Comment on Representation Relating to Draft Plan

**Comment on the Representations to
Draft Wan Chai Outline Zoning Plan No. S/H5/28**

Lee Theatre Realty Limited
Representation on the Draft Wan Chai Outline Zoning Plan No. S/H5/28
Relating to Lee Theatre Plaza, 99 Percival Street, Causeway Bay

**Leighton Property Company Limited
Representation on the Draft Wan Chai Outline Zoning Plan No. S/H5/28
Relating to Leighton Centre, 77 Leighton Road, Causeway Bay**

Figure 4 : 135mPD OZP and SBDG Compliant Scheme.

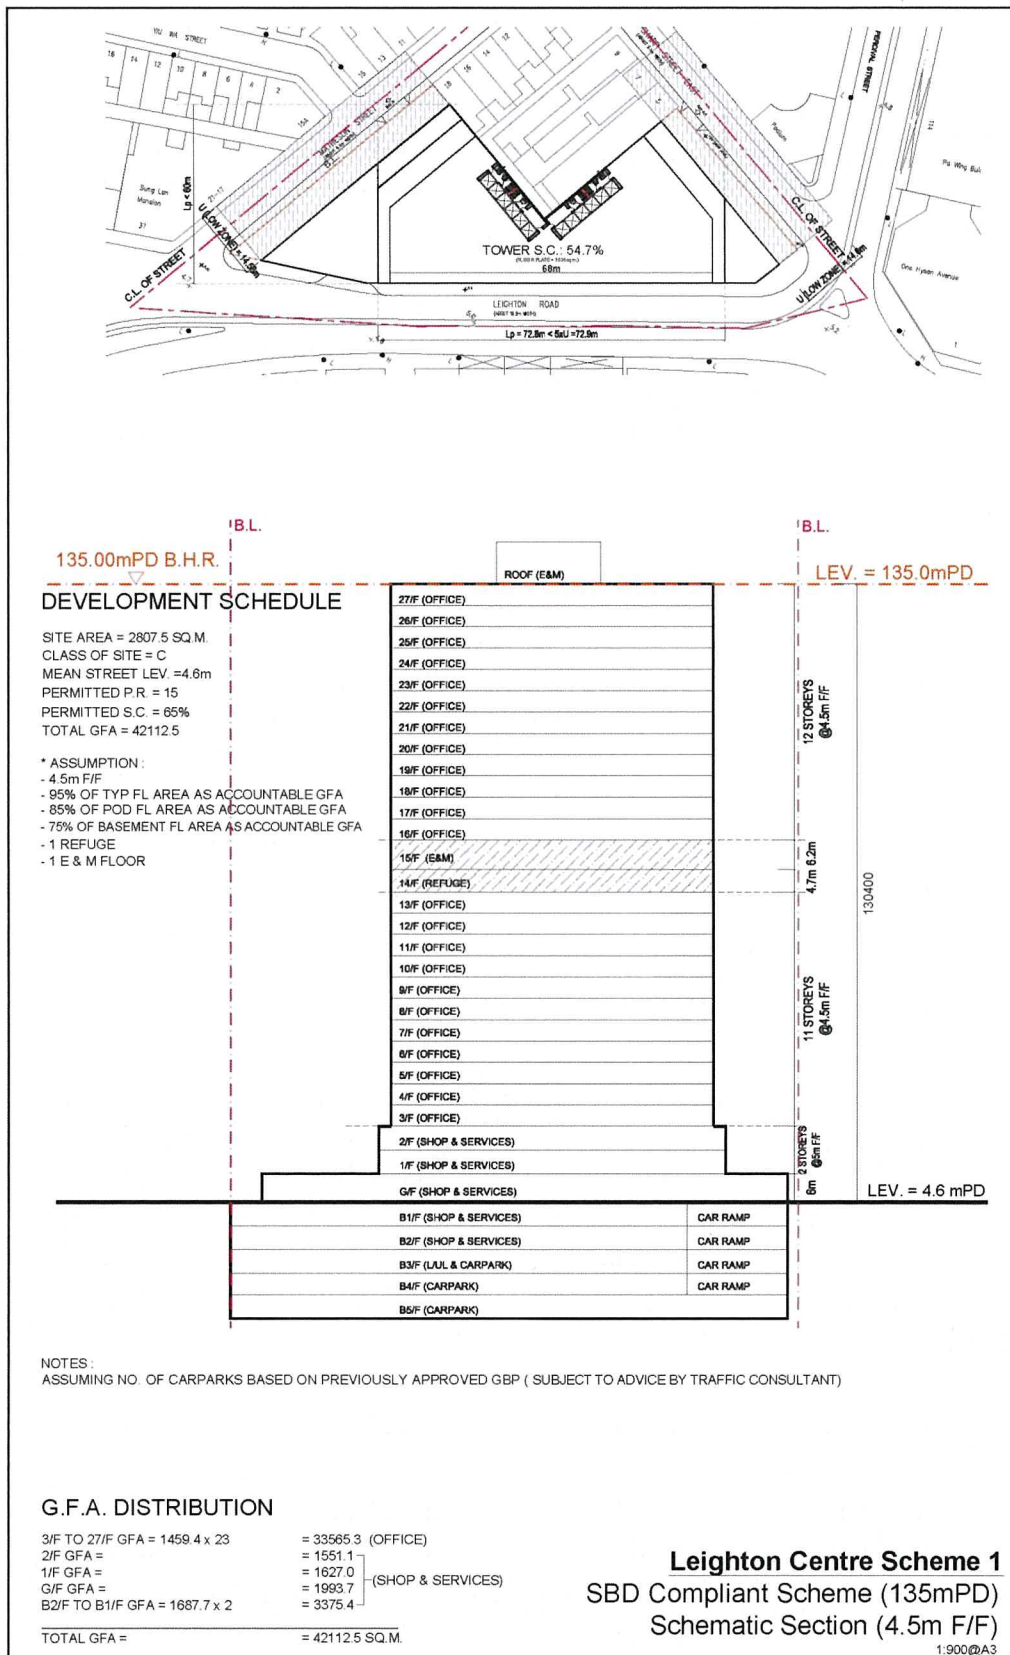
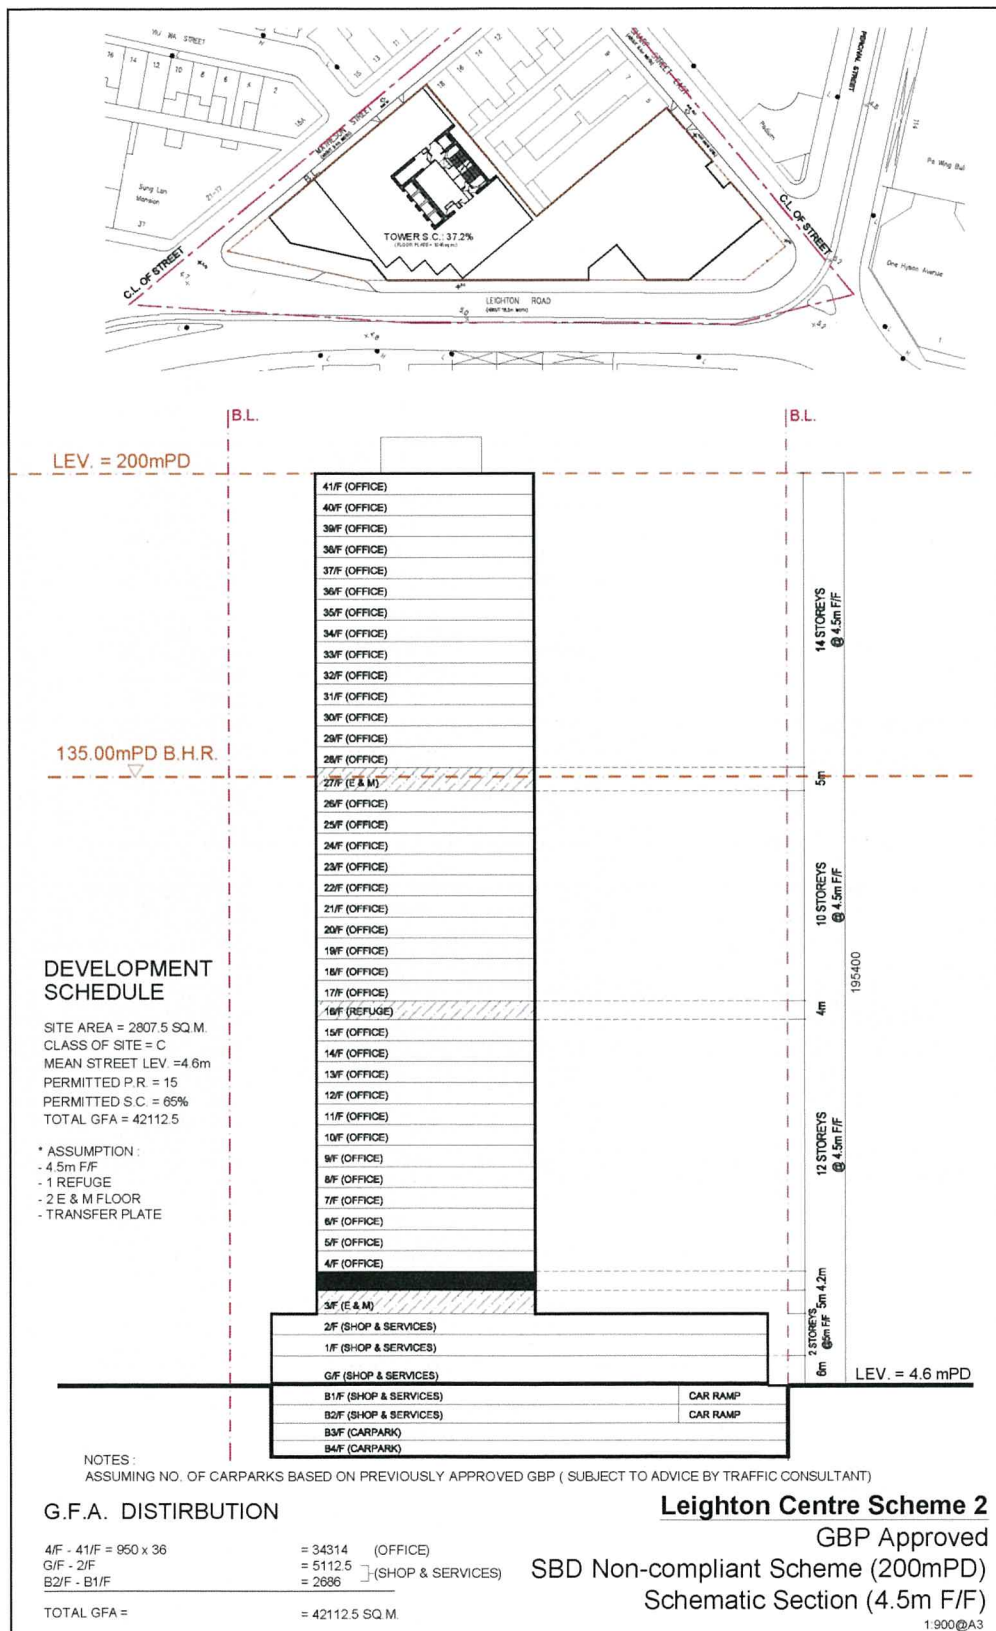
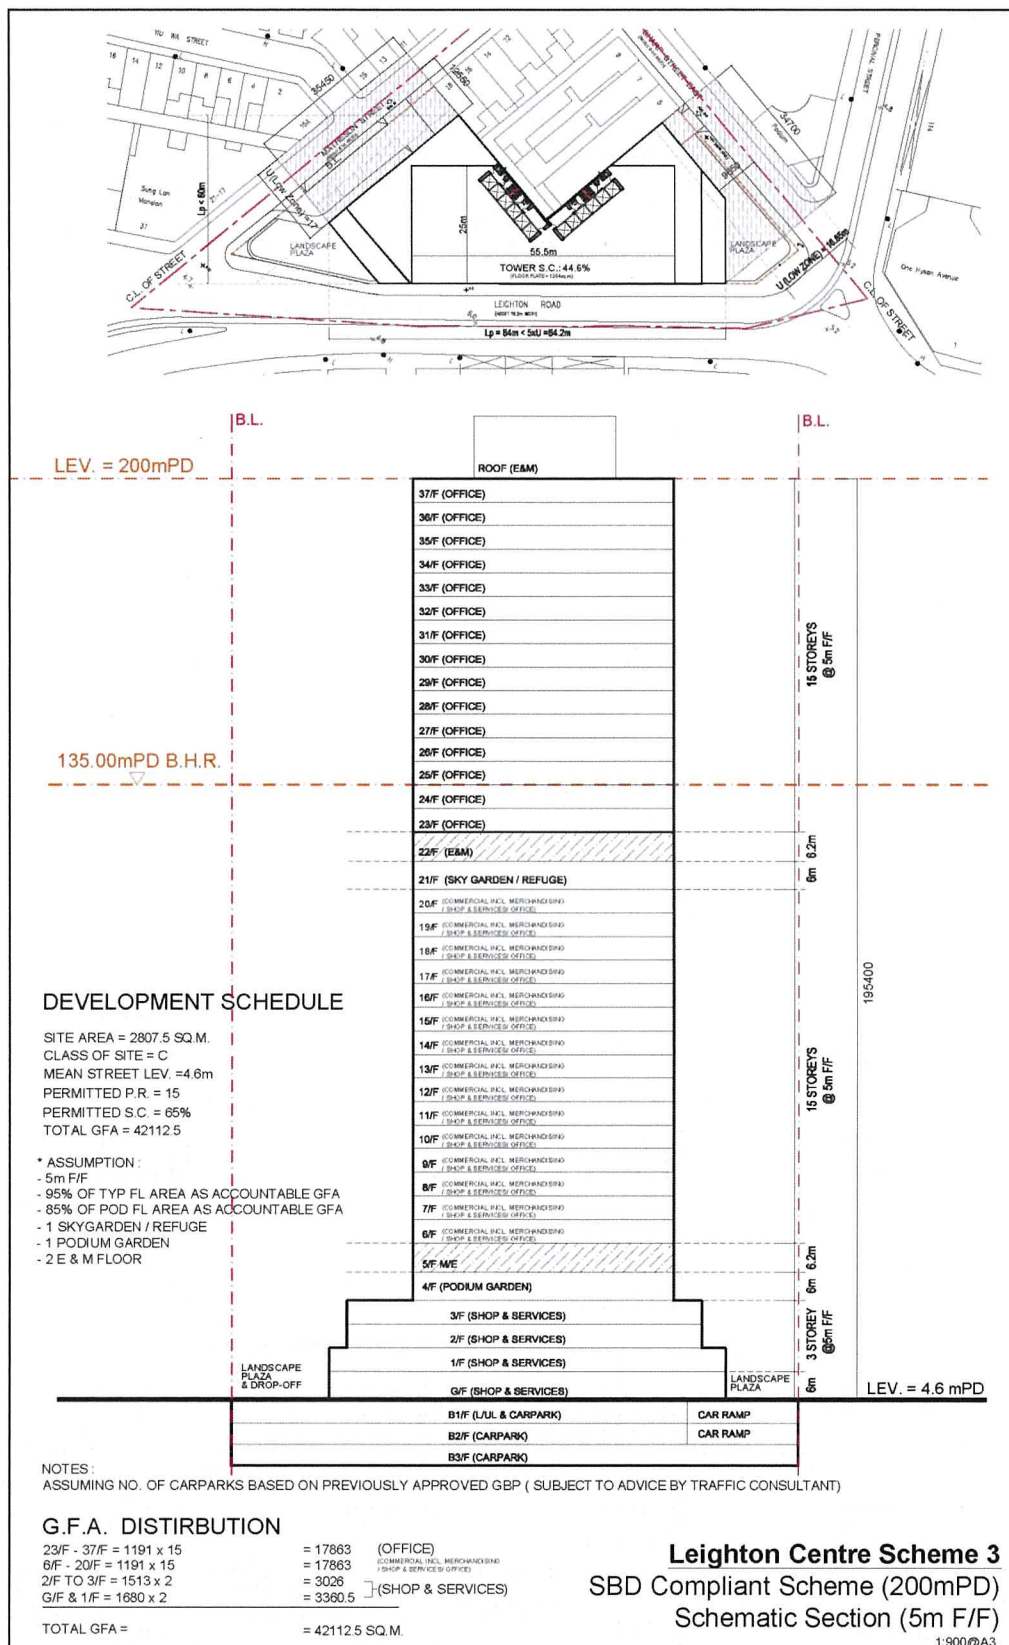
- 10.1 The Representor's AP has been requested to prepare three schemes to illustrate the different options for the site. The first scheme (**Figure 4**) is the 135mPD scheme showing the impact of the normal application of the SBDG on the development of the Leighton Centre site under the 135mPD BHR. The Second Scheme is the Approved GBP scheme (**Figure 5**) and the third is an indicative scheme of some of the features that could be incorporated if the BHR was raised to 200mPD (**Figure 6**).

- 10.2 This scheme is designed to comply with the proposed 135mPD BHR (see **Figure 4**). To comply with the SBDG it is necessary to have small podium setback at the ground floor level on both Matheson Street and Sharp Street East. The length of the tower is also limited under SBDG. Due to the unusual shape of the site the

- 10.3 The relatively low BHR of 135mPD necessitates the provision of two basement floors below ground level to accommodate the balance of the GFA. This is contrary to the assumption made by PlanD not to have any such floor for these uses in the basement. With the parking and loading/unloading requirements, this would effectively mean provision of 5 basement levels, which is a very large and prohibitively expensive excavation. As a business case, this scheme is inferior to the Approved GBP Scheme and not a realistic viable commercial option for the Representor.

- 10.4 The approved GBP Scheme is 200mPD (see **Figure 5**), and has a more efficient tower footprint. The 3 floors of podium are large floorplates, with some voluntary setbacks located in a few places. There are no green features and are 2 storeys of retail in the basement levels. The floor-to-floor height is 4.5 for the tower. The scheme was never intended to be built without substantial modifications as the detailed design process progressed, but it is a scheme that can be built and operated as a very standard commercial development. It would not be a typical Hysan development as it has no green features, no place-making contribution and it also has no green features. It has very little public benefit. It is however a scheme that from a business case perspective is possible to justify, while not congruent with the best-practice redevelopment ethos of Hysan Place.

- 10.5 This scheme is the win-win option for the Representor, the TPB and the general public. The 200mPD scheme (see **Figure 6** is simply indicative, however, as detail design proceeded a scheme which is SBDG compliant, added to the functionality of the public realm in the area and contributes to place making in Causeway Bay would be developed. The 200mPD BHR would permit a building to be built which has better placed voluntary setbacks, such as Lee Garden One (see other examples in **Figure 7**) reducing the pressure on Matheson Street and Sharp Street East for both pedestrians and vehicles. There would be a redesigned run-in and run-out which would help with traffic issues and an on-site drop-off

<p>(ii) The representers have provided their alternative schemes at Lee Theatre Plaza site and Leighton Centre site (Drawing H-1 and Drawing H-2 as extracted from the representations in Annex VI). The further relaxation of the BHR from 135mPD to 165mPD for Lee Theatre Plaza site and from 135mPD to 200mPD for Leighton Centre site allows a building design to accommodate a 5m floor-to-floor height to cope with modern requirements, incorporate green features and amenities such as sky gardens, podium gardens, reduction in podium bulk for better air ventilation, and incorporate drop-off area, landscaped plaza and incorporate run-in and run-out to improve pedestrian and vehicular traffic flows. The proposed 165mPD for the Lee Theatre Plaza site and 200mPD for the Leighton Centre site would not result in adverse visual impact as it is not visible in any vantage points produced by PlanD, particularly to the viewing point at Stubbs Road Lookout. There is no justification given in the OZP amendment that why 135mPD is more appropriate than the alternative BHRs at the sites of Lee Theatre Plaza (R2) for 165mPD and Leighton Centre (R3) for 200mPD</p> <p>(c) <u>Urban Design and Visual</u></p> <p>No significant visual impact is perceived when viewing from the Stubbs Road Lookout Point thereby affecting</p>	<p>exception rather than a rule. It is therefore inappropriate to apply the approach adopted in Tsim Sha Tsui OZP to the subject OZP</p> <p>(iv) The existing BH and plot ratio (PR) of Lee Theatre Plaza are about 104mPD and 15 respectively, while that of Leighton Centre are 83.5mPD and 15 respectively. For Leighton Centre, there is also a set of building plans with a BH of 200mPD and a PR of about 15 which was first approved by the Building Authority on 24.4.2009. In determining the BHRs, a BHR of 135mPD is sufficient to accommodate the permissible development intensity for commercial development. Nevertheless, the building plans of Leighton Centre with approval by the Building Authority before imposition of BHRs in 2010 may proceed subject to the provision of the Buildings Ordinance</p> <p><u>Assumptions in deriving BHR</u></p> <p>(v) The assumptions adopted by PlanD were provided in Annexes D2 and D3 & E1 to E5 of TPB Paper No. 10415. According to the basic building profile, a BHR of 135mPD is able to accommodate the permissible GFA under Building (Planning) Regulations (B(P)R) for the Lee Theatre Plaza site and Leighton Centre site with 25% GFA concession (including the average 'disregarded GFA (e.g. mandatory features, plant rooms, etc. other than car parks)' for non-domestic buildings</p>
